PIC32MZ Embedded Connectivity (EC) Family Silicon Errata and Data Sheet Clarification

The PIC32MZ Embedded Connectivity (EC) family devices that you have received conform functionally to the current Device Data Sheet (DS60001191C), except for the anomalies described in this document.

Data Sheet Clarifications

FIGURE 8-1: PIC32MZ EC FAMILY OSCILLATOR BLOCK DIAGRAM

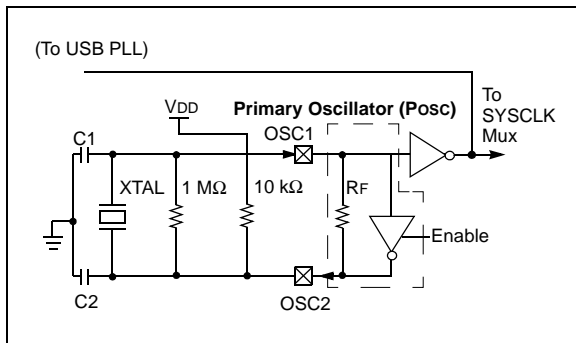
3. Module: Primary Oscillator

The Primary Oscillator logic in **Figure 8-1: “PIC32MZ EC Family Oscillator Block Diagram”** of the current device data sheet omitted a pull-up resistor (R_K), which is necessary to ensure stable start-up of the Primary Oscillator when it is running from a crystal. This resistor must be 10 k Ω and connected between OSC2 and VDD.

The following figure shows the amended portion of the diagram.

Crystals with a speed of 4 MHz to 24 MHz that meet the following requirements will meet the PIC32MZ oscillation requirements when configured as depicted in [Figure 8-1](#).

1. Manufacturer Drive Level (min) < 10 μ W (hard requirements, 1 μ W preferred).
2. Manufacturer ESR \leq 50 Ω (hard requirement, lower is better).

1. PIC32 $C_{IN} = C_{OUT} = \sim 4$ pF (PIC32 OSC1 and OSC2 package pin capacitance).
2. $C1_{MFG} = C2_{MFG} =$ Manufacturer Recommended Load Capacitance.
3. $C_{LOAD} = \{([C_{IN} + C1_{MFG}] [C2_{MFG} + C_{OUT}]) / [C_{IN} + C1_{MFG} + C2_{MFG} + C_{OUT}]\} +$ estimated PCB stray capacitance (2.5 pF)
(Simplified) $C_{LOAD} = (((C_{IN} + C1_{MFG}) / 2) + 2.5 \text{ pF})$.

- $C2 = C_{LOAD}$
- $C1 = (C_{LOAD} - 2 \text{ pF})$
